SOLICITATION AMENDMENT MODIFICATION DE L'INVITATION

Title - Sujet PIRATES Turret Update		
Solicitation No. - N° de l'invitation W7701-186676/A		Amendment No. - N° modif. 004
Client Reference No. - N° de référence du client W7701-186676		Date 2018-01-30
GETS Reference No. - N° de référence de SEAG PW-\$BAL-001-17299		
File No. - N° de dossier BAP-7-40215 (001)	CCC No./N° CCC - FMS No./N° VME	
Solicitation Closes - L'invitation prend fin at - à 02:00 PM on - le 2018-02-15		Time Zone Fuseau horaire Heure Normale du l'Est HNE
F.O.B. - F.A.B.		
Plant-Usine: <input type="checkbox"/> Destination: <input checked="" type="checkbox"/> Other-Autre: <input type="checkbox"/>		
Address Enquiries to: - Adresser toutes questions à: Tremblay, Marial		Buyer Id - Id de l'acheteur bal001
Telephone No. - N° de téléphone (418) 677-4000 (4159)		FAX No. - N° de FAX () -
Destination - of Goods, Services, and Construction: Destination - des biens, services et construction: Defence R & D Canada - Valcartier / R et D Défense Canada - Valcartier 2459 route de la Bravoure Québec (Québec) G3J 1X5

Questions/Answers during optional site visit on January 25th, 2018

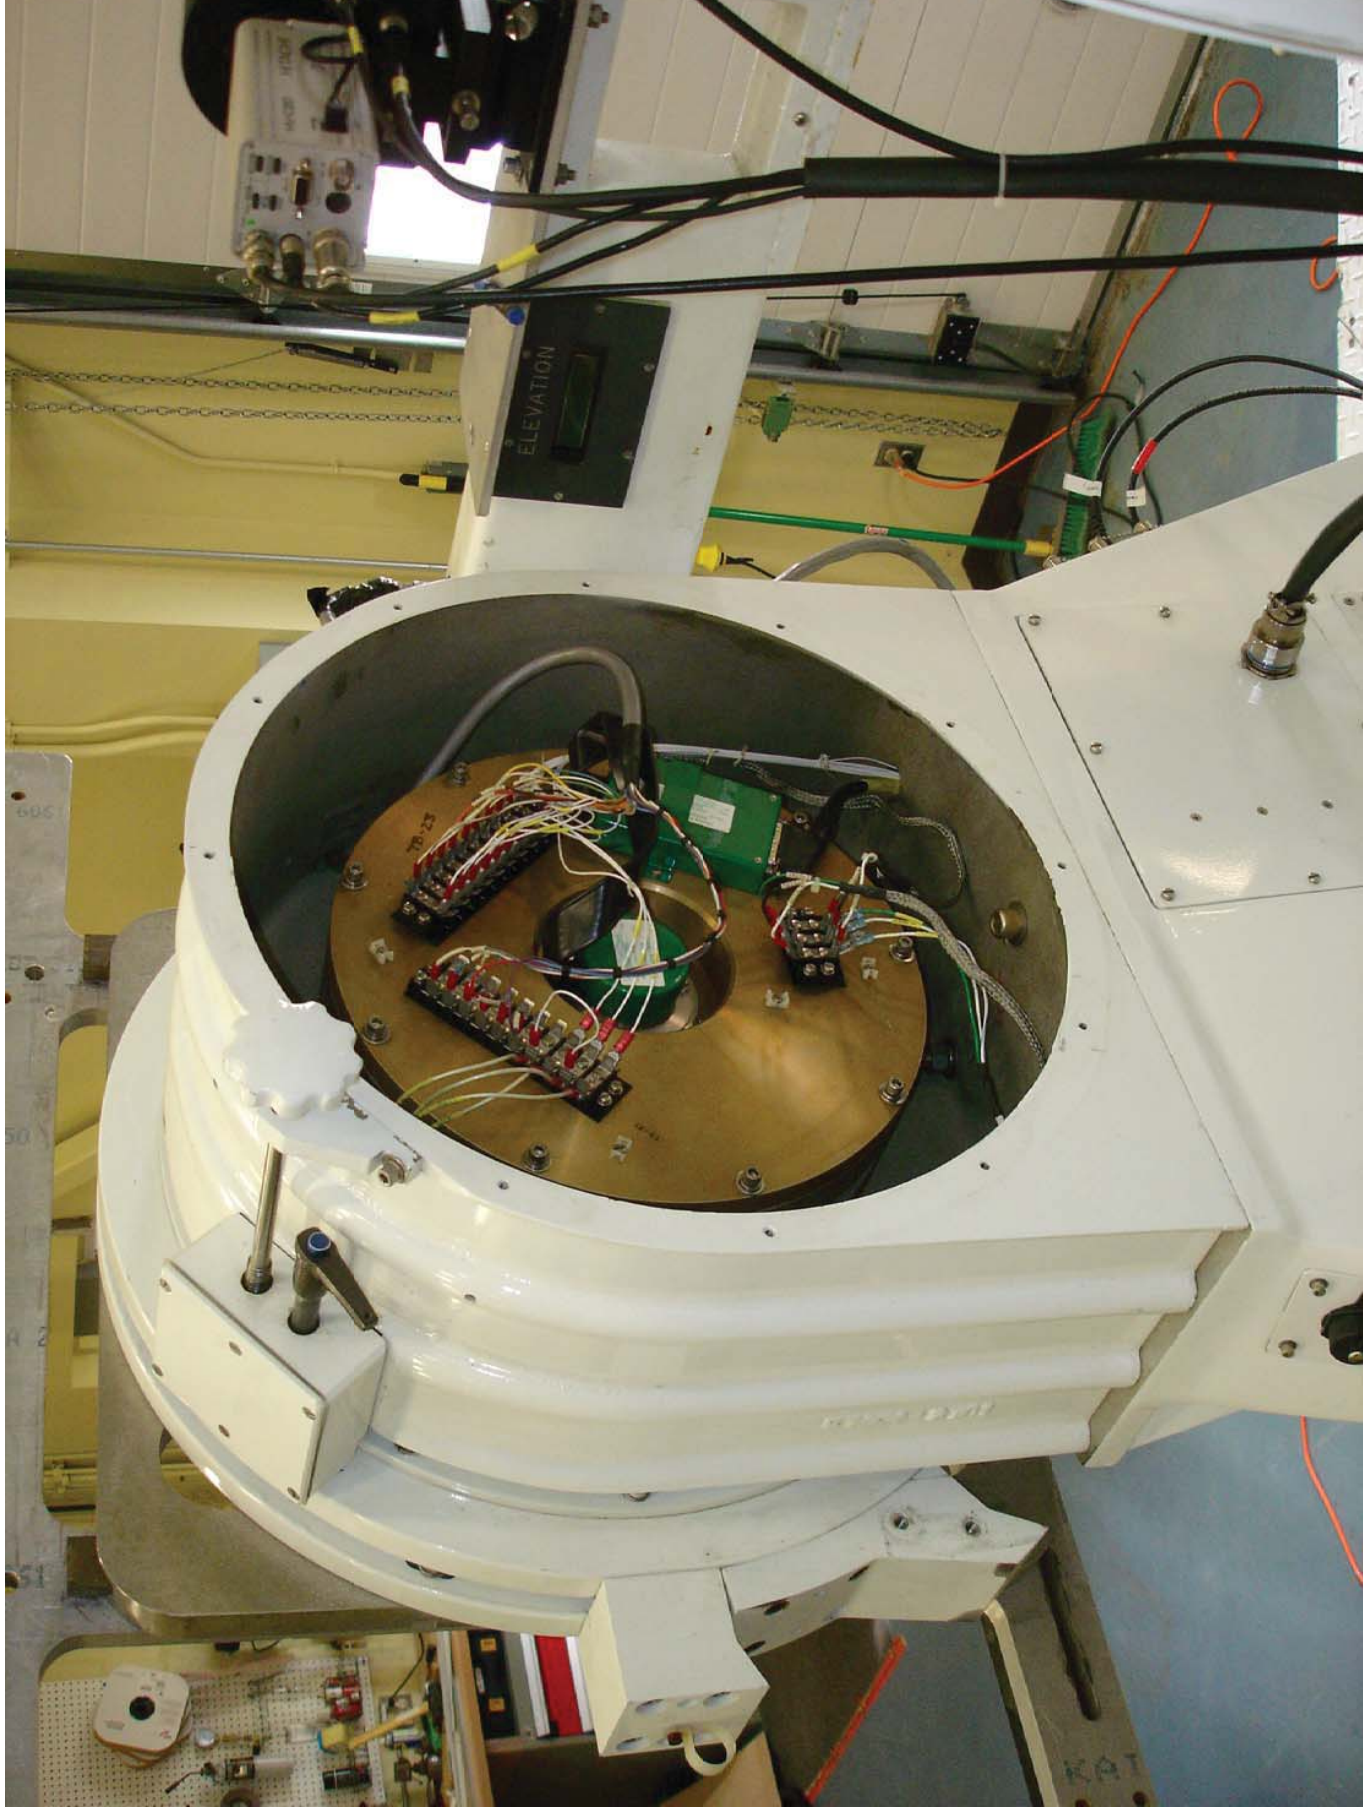
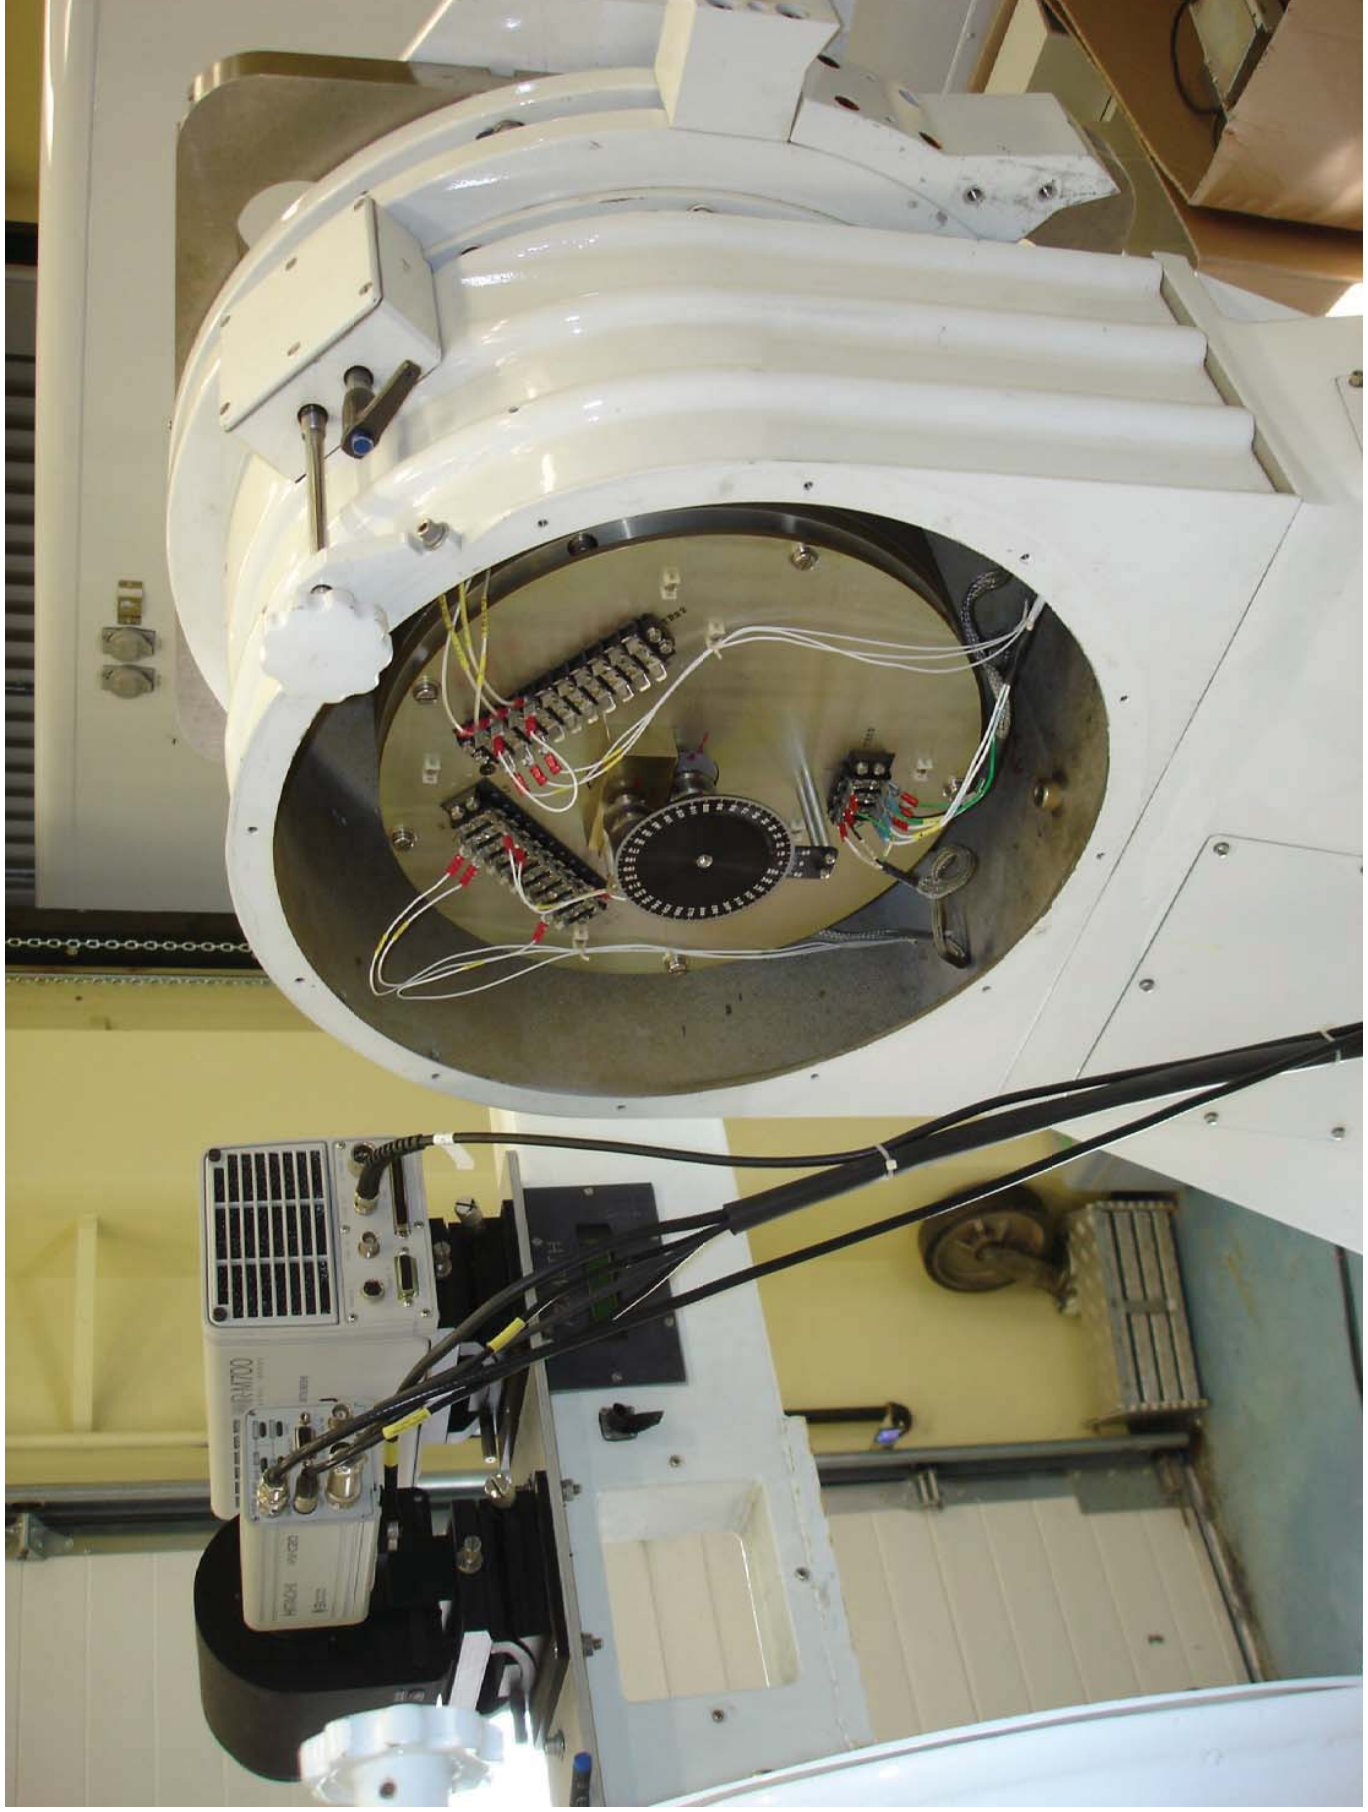
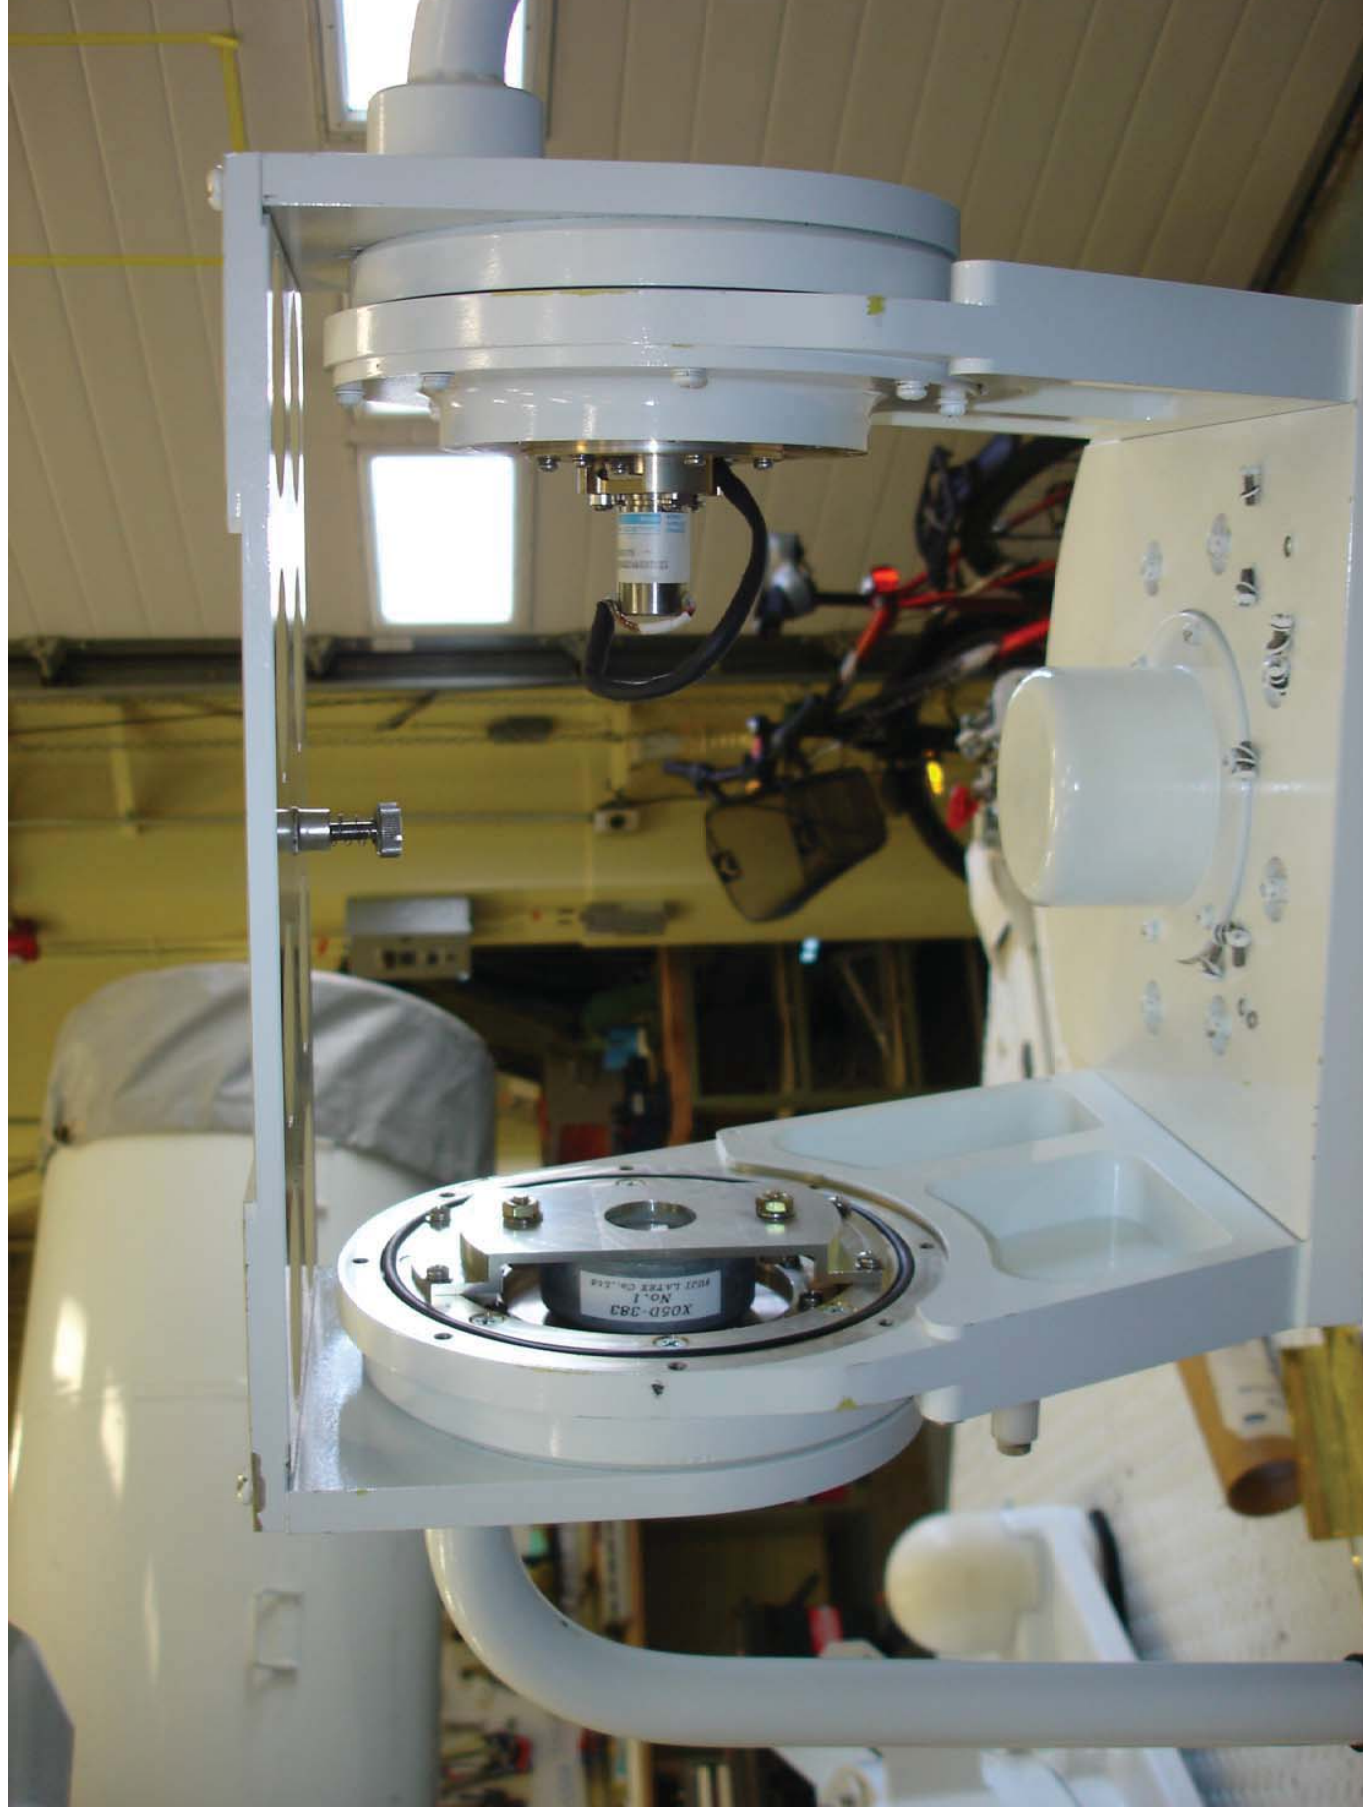
Can you supply us with the pictures + figure 2-2 of the manual?

Answer 23: Pictures and Figure 2.2 of the manual are attached to this amendment.
